CHILDREN'S HOSPITAL
OF ORANGE COUNTY

TOWER II

LEVEL 3 ENLARGED PLAN
AREA - D

A3.3D

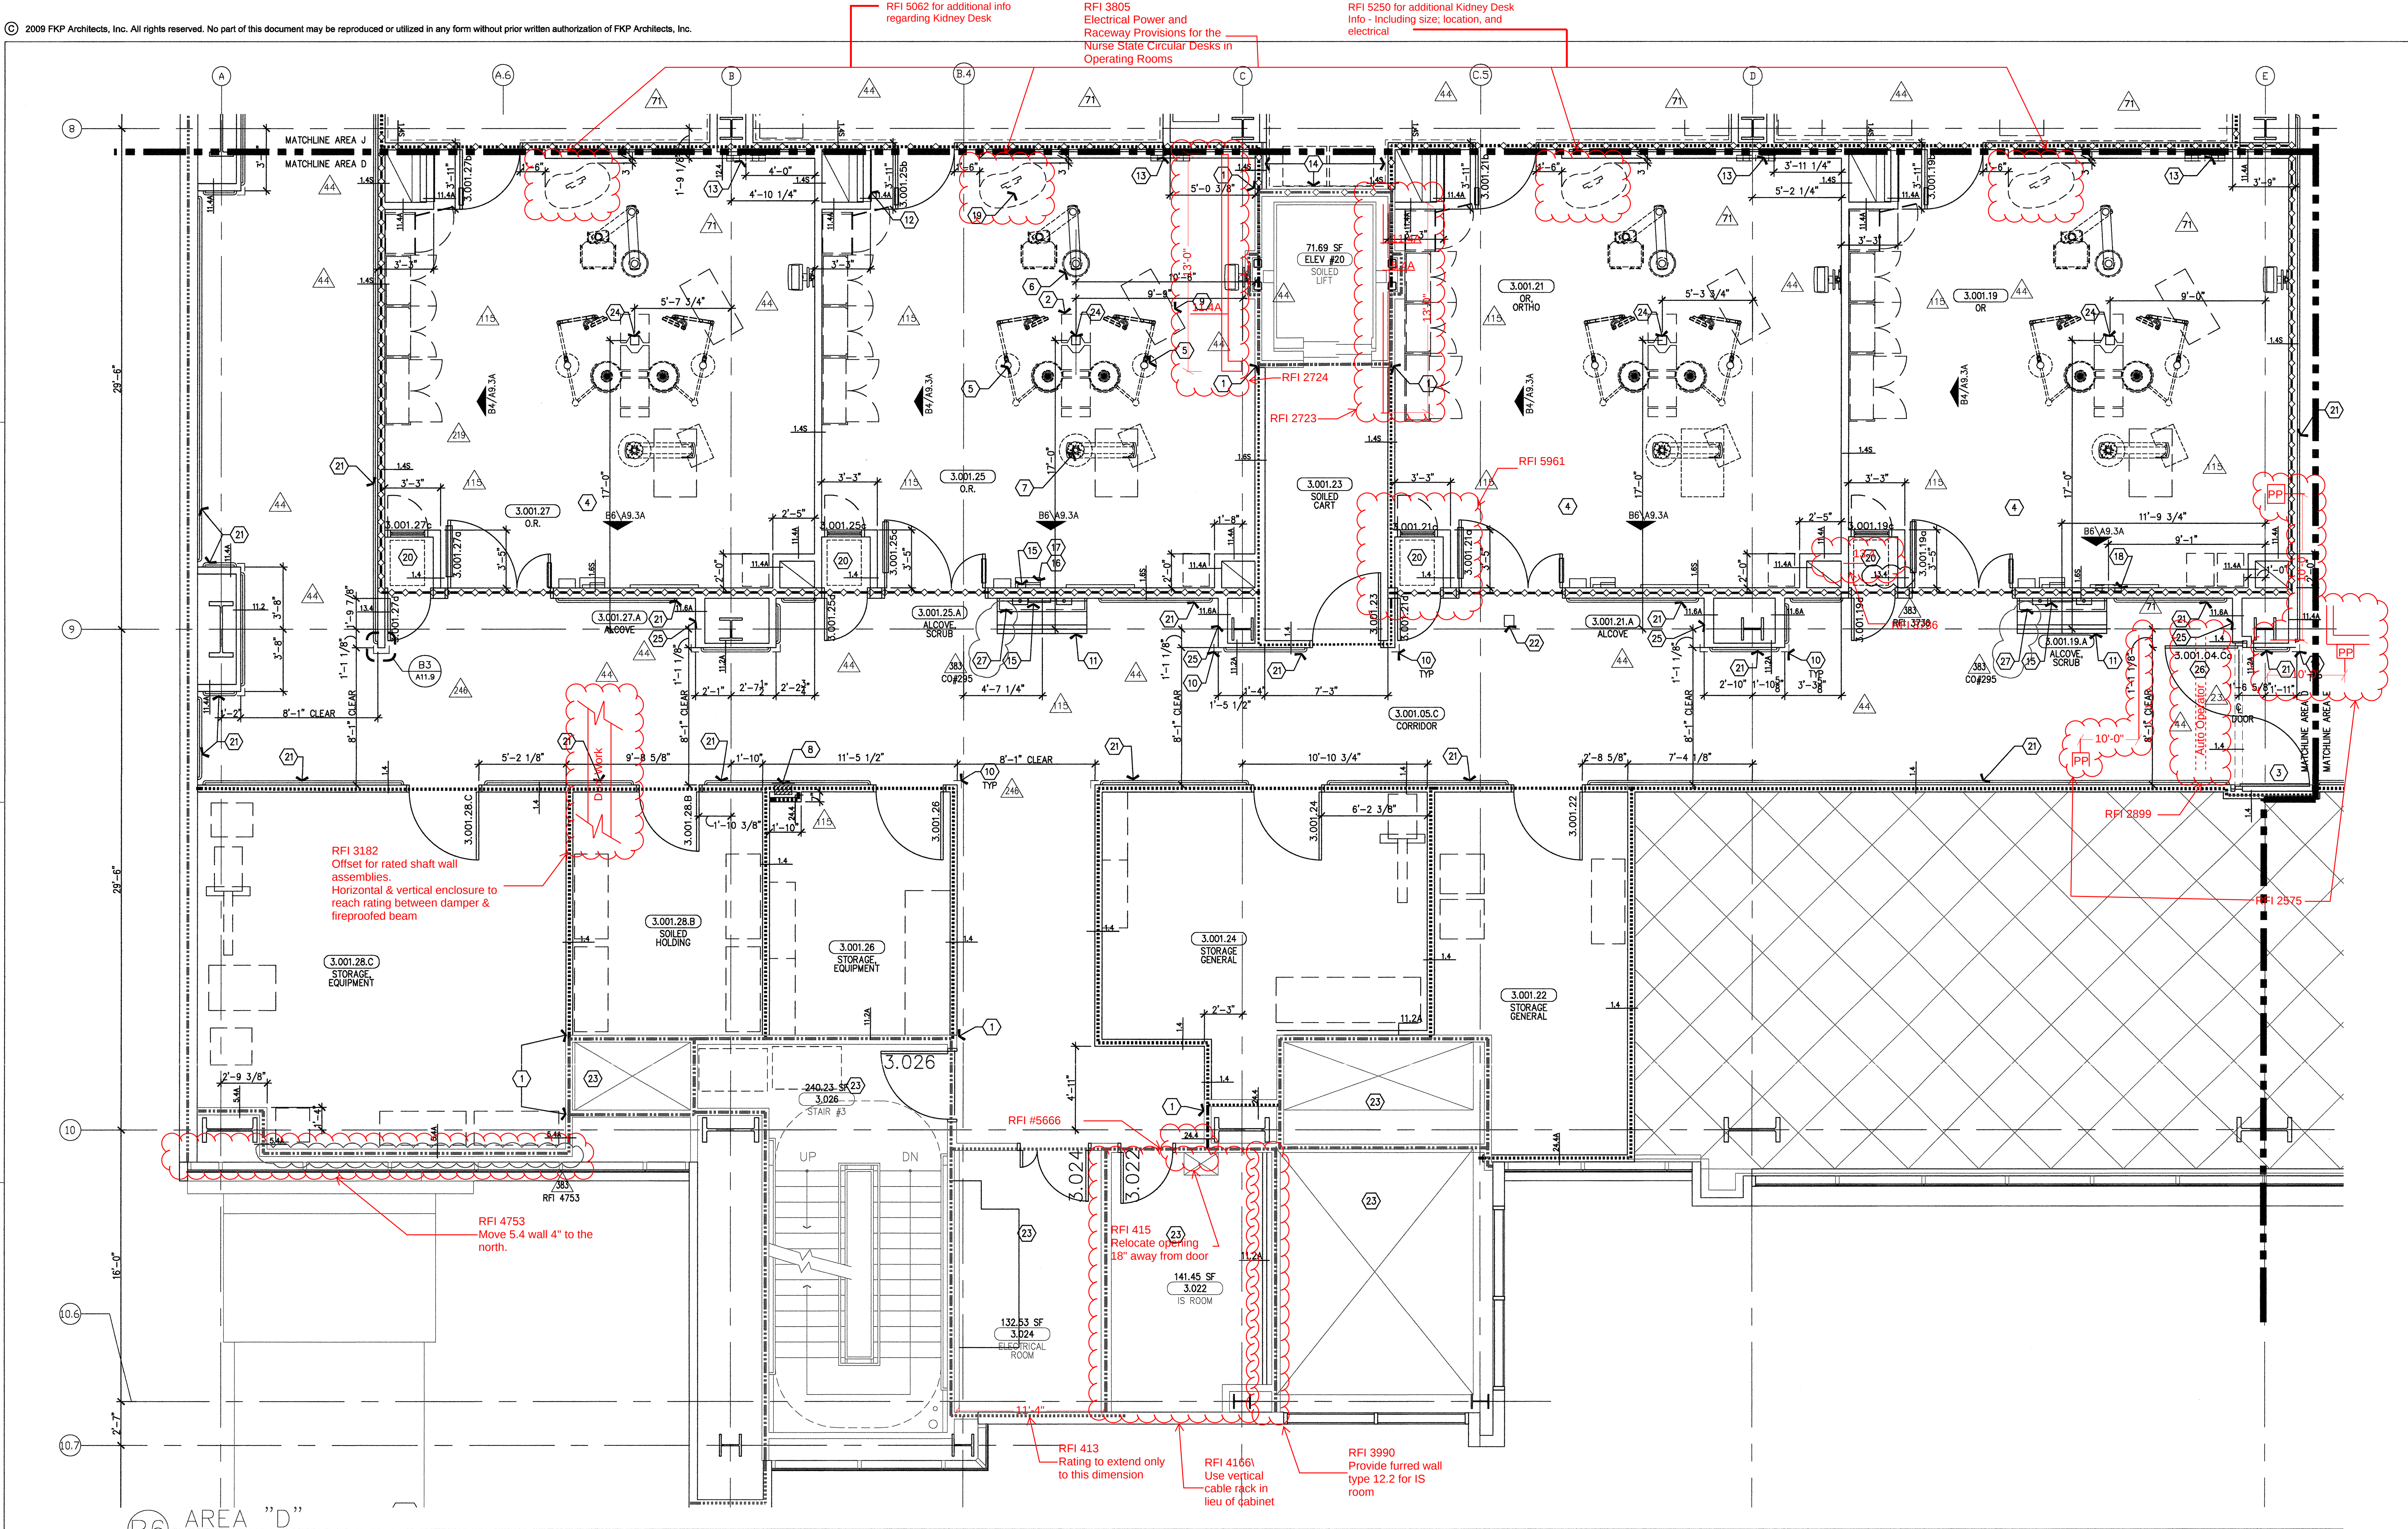
RFI 4221
See detail for attachment to wall
See A6/A11.3.1 for backing detail
